SUBJECT: Permit Modification Request for Section 404 Individual Permit and Section 401 Individual Water Quality Certification for the new location facility from SR 2011 to the Haw River at US 220, Greensboro, Guilford County; Division 7; TIP No. R-2413A

The North Carolina Department of Transportation (NCDOT) awarded the design-build team this project on April 8, 2014 to construct projects R-2413A, R-2413B, and I-5110. Sections R-2413A and B were authorized by the USACE and NCDWR as referenced above. We are requesting a modification in the permits for two Permit Sites: 7A and 18 for Section R-2413A.

PROJECT REFERENCE NO. R-2413A	SHEET NO. 13
RW SHEET NO.	
ROADWAY DESIGN ENGINEER	HYDRAULICS ENGINEER
REVISED 9/22/2014, S/62015 PERMIT DRAWING SHEET 21 OF 81

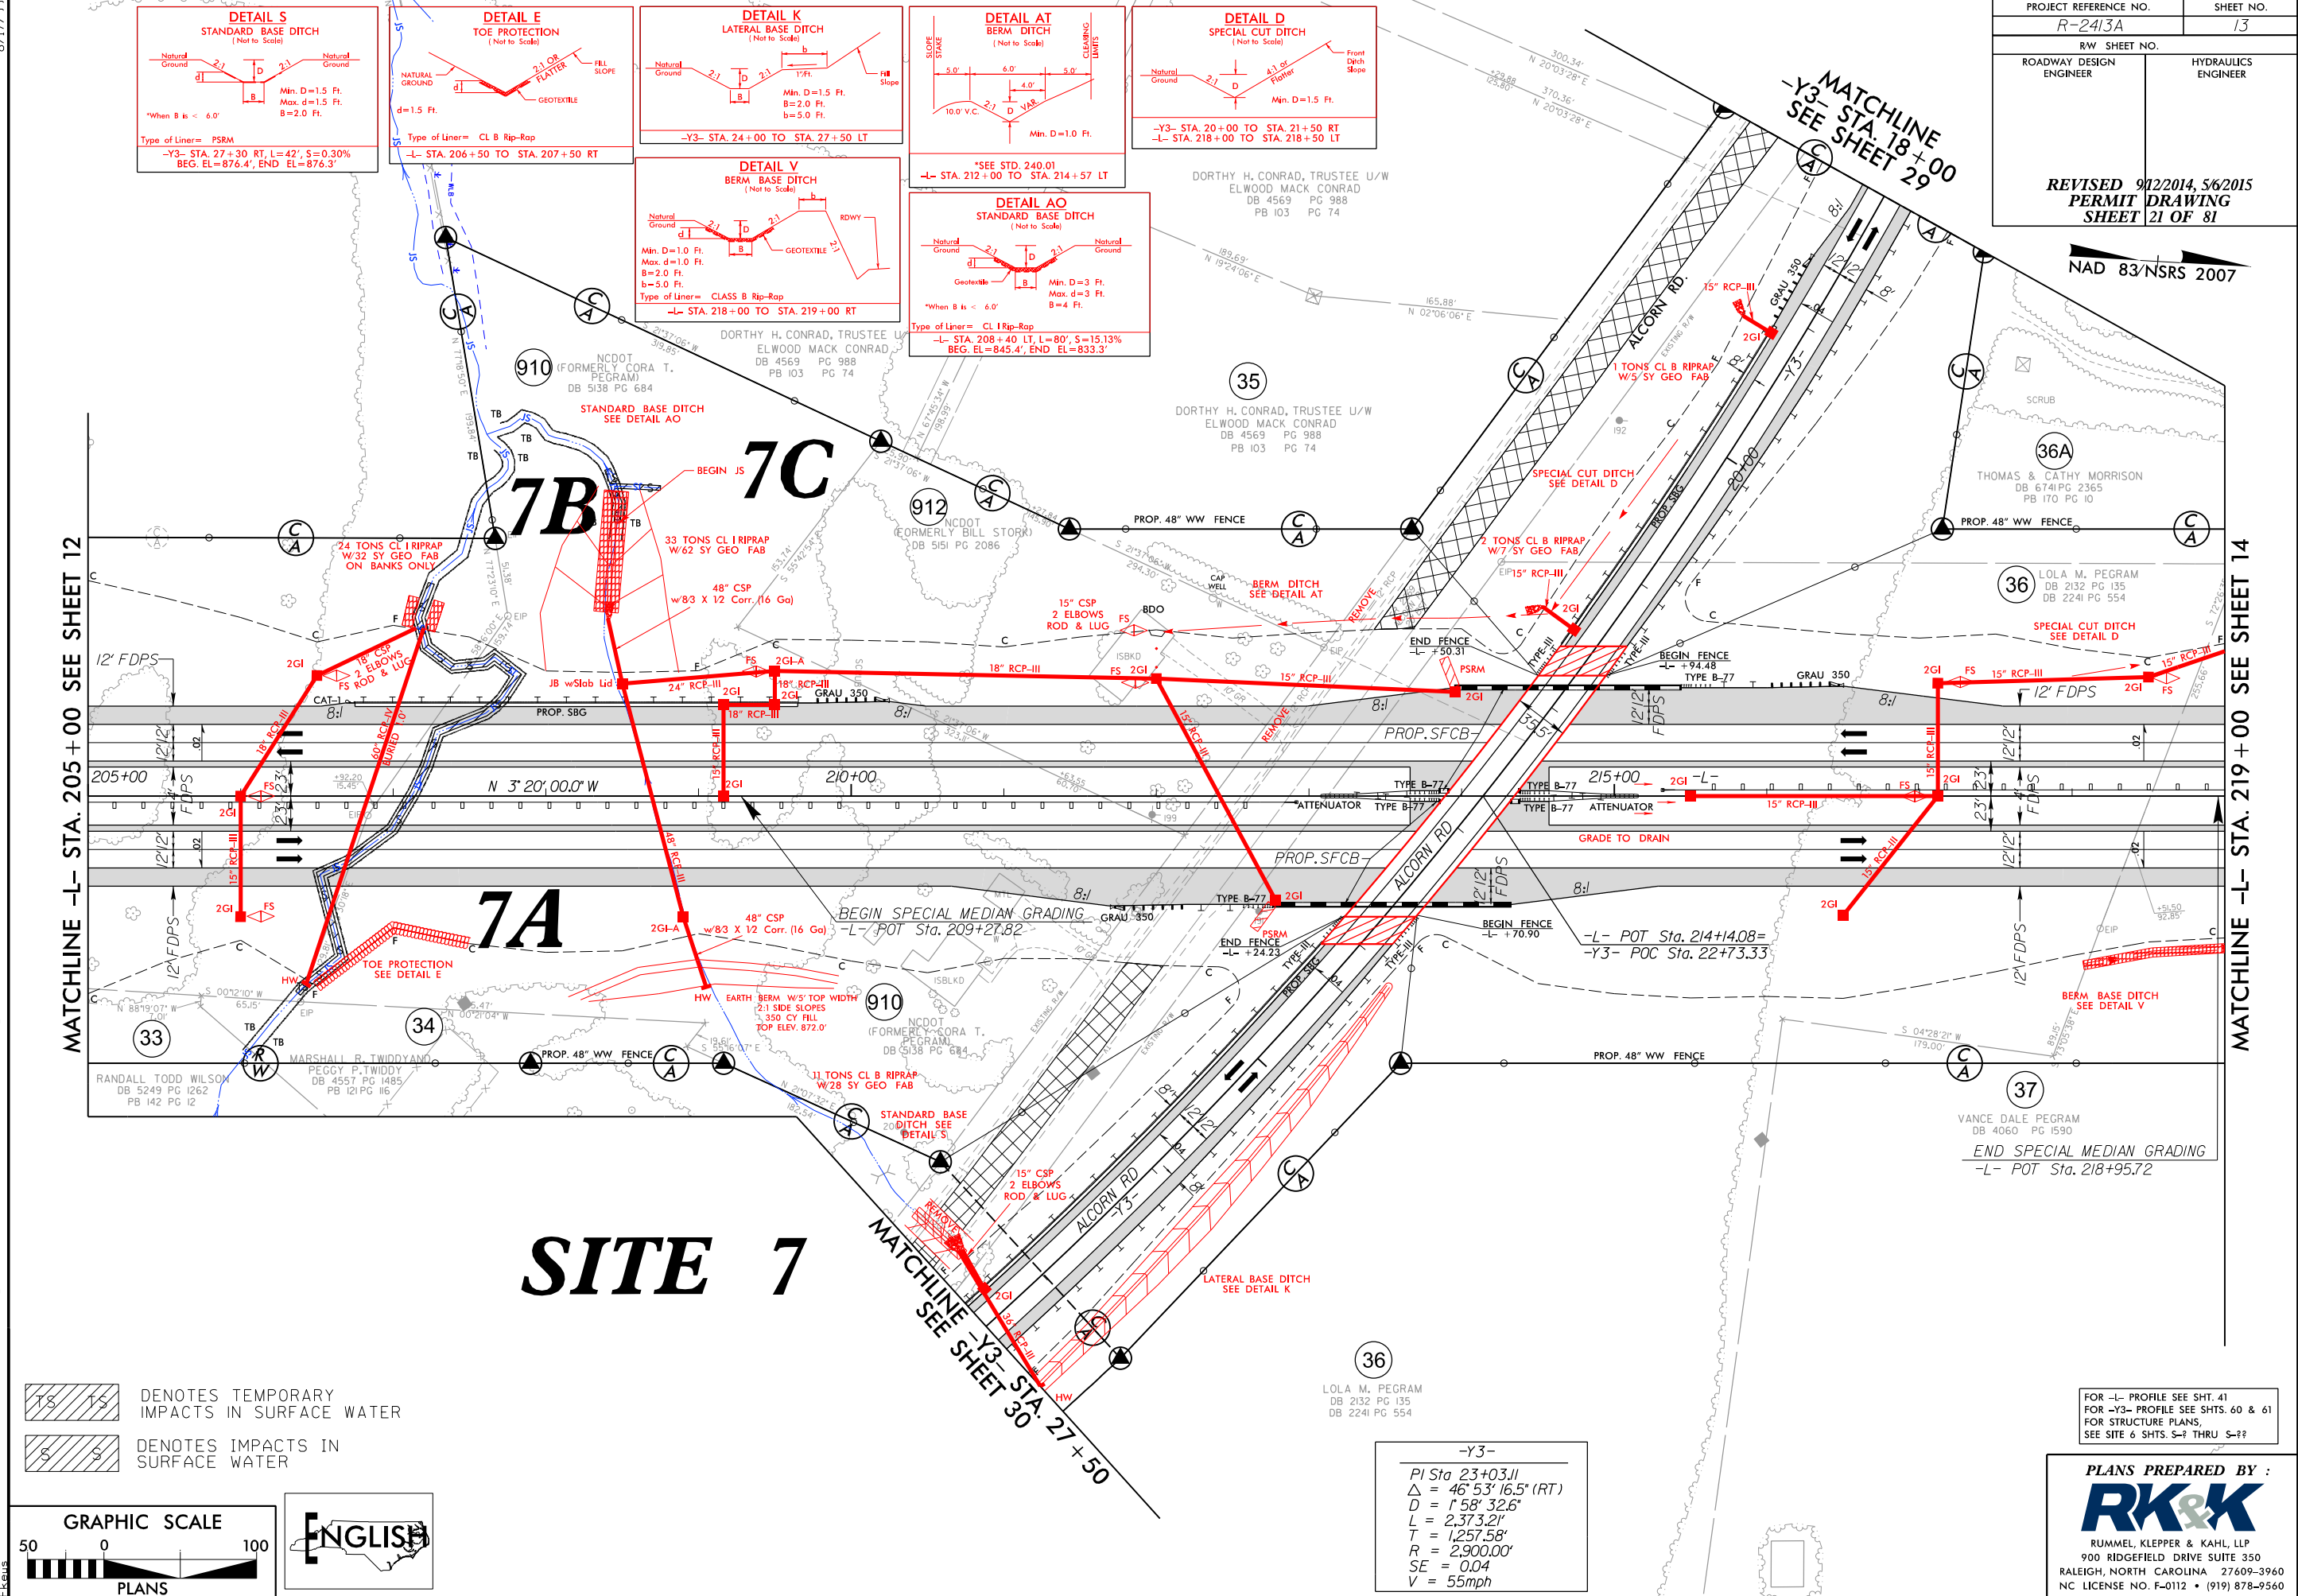
Permit Site 7A. As you are aware from the site review held on January 27 and 28, 2015, the downstream end of the culvert is angled such that it would likely cause future erosion on the north bank. In response to a question contained in your January 29 email, the culvert was installed at the correct angle, and either the stream meandered slightly from its original course or it was not located precisely enough when initially surveyed. To correct this outlet, the "peninsula" of existing soil jutting into the stream from the north bank will be removed and the north bank will be sloped back and protected with rip rap. A larger rip rap will be installed first, and a smaller rip rap will then be applied to fill in the gaps. This will not extend below mean high water. This modification will require the bank stabilization to extend 10 more linear feet (LF) into an area originally considered temporary impacts. As such, the temporary impacts will decrease by 10 LF (new total of 11 LF) and the bank stabilization will increase by 10 LF (new total of 55 LF). Please see Revised Permit Drawings 21-23 and 79 of 81.

PROJECT REFERENCE NO. R-2413A	SHEET NO. 22A
RW SHEET NO.	
ROADWAY DESIGN ENGINEER	HYDRAULICS ENGINEER
REVISED 9/22/2014, 5/6/2015 PERMIT DRAWING SHEET 55 OF 81

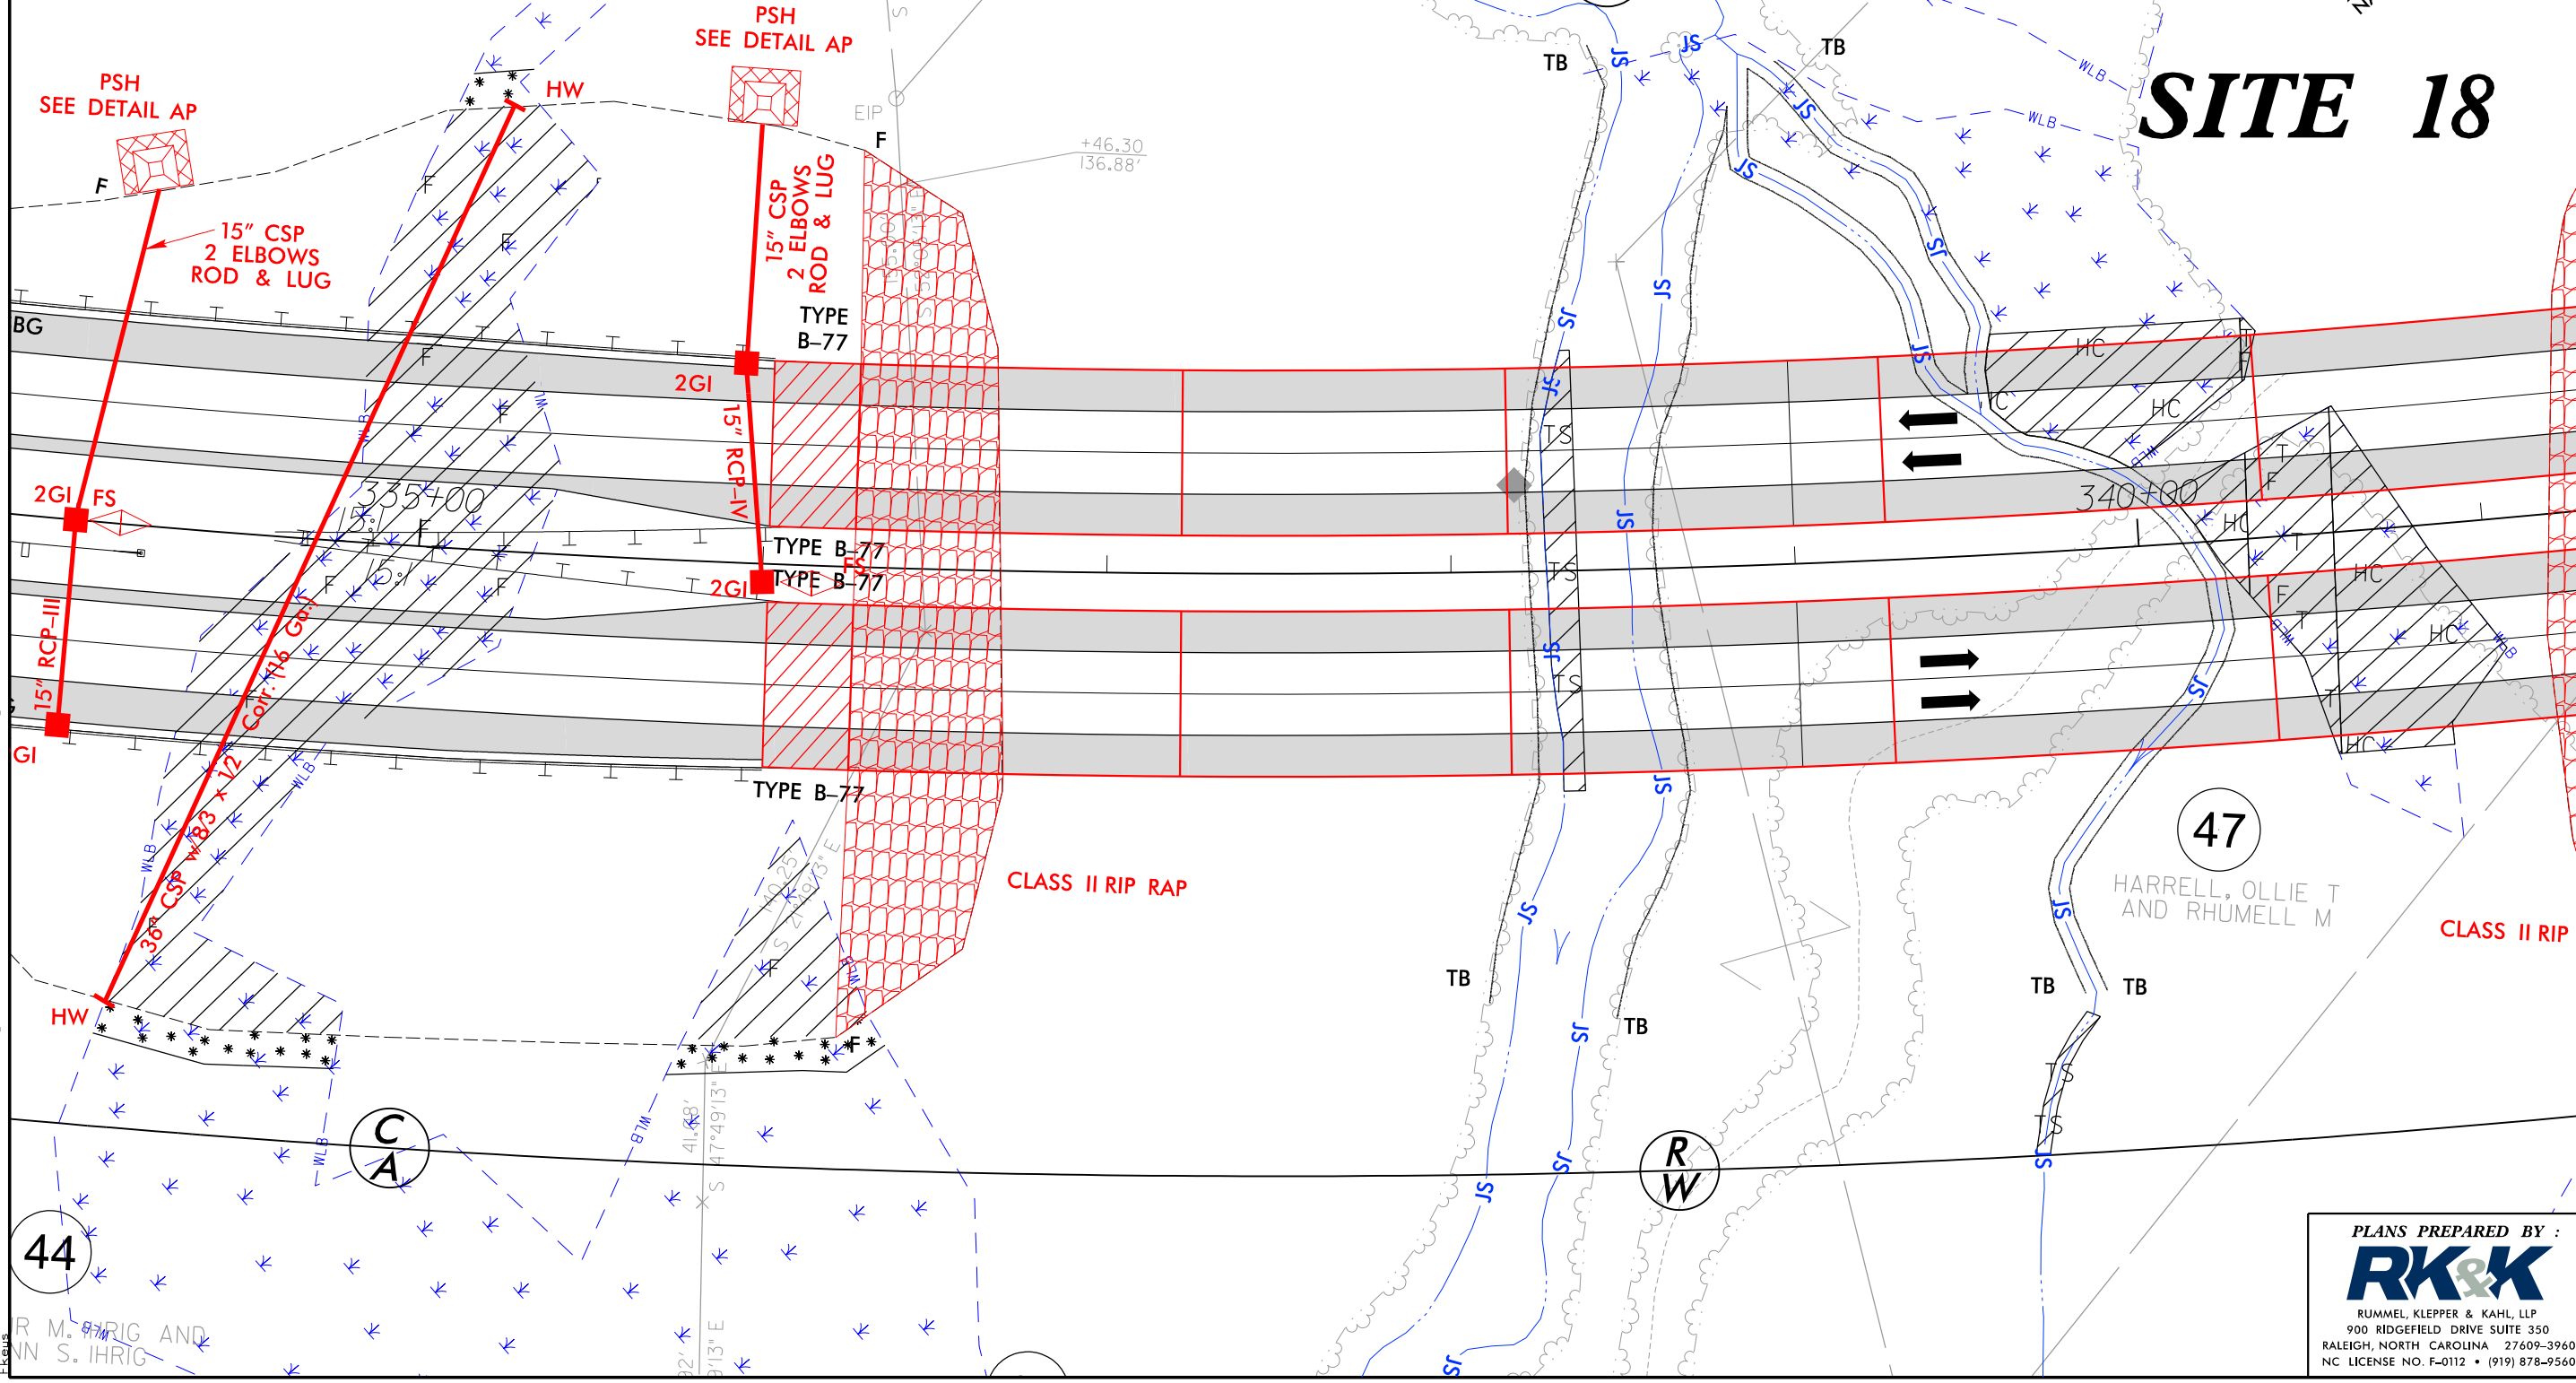
Permit Site 18. NCDOT's understanding of the 33CFR323.3(c)(2) was that it was not necessary to include the impacts from the bents from this bridge as permanent and the project was permitted as such.

However, based upon USACE comments and internal NCDOT discussions, we have updated the impact sheet to reflect <0.01 ac (40 ft²) of permanent wetland impacts from the bents. Permit Drawings 53-55 and 81 of 81 have been revised.
